State of New Mexico **Energy, Minerals and Natural Resources** Oil Conservation Division 1220 S. St Francis Dr. Santa Fe, NM 87505

Permit 184363

Operator Name and Address BTA OIL PRODUCERS, LLC						2. OGRID Number 260297						
104 S. Pecos						3. API Number						
Midland, TX 79701						30-025-41773					}

PERMIT COMMENTS

WELL LOCATION AND ACREAGE DEDICATION PLAT

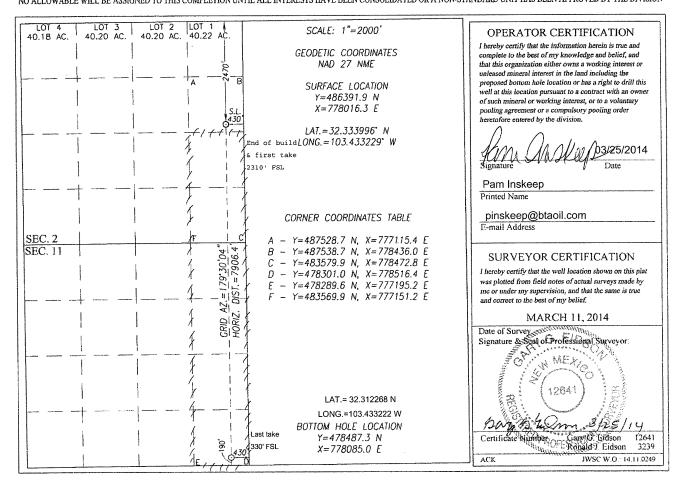
Created By	Comment	Comment Date
	Non-Standard Location request submitted to Santa Fe. Any potential hazardous H2S volume would be minimal concentration. No contingency plan should be required.	4/9/2014
PINSKEEP	C102, as shown on this site/submittal, is incomplete. I will email a copy of a correct C102 to the attention of Donna Mull.	4/9/2014
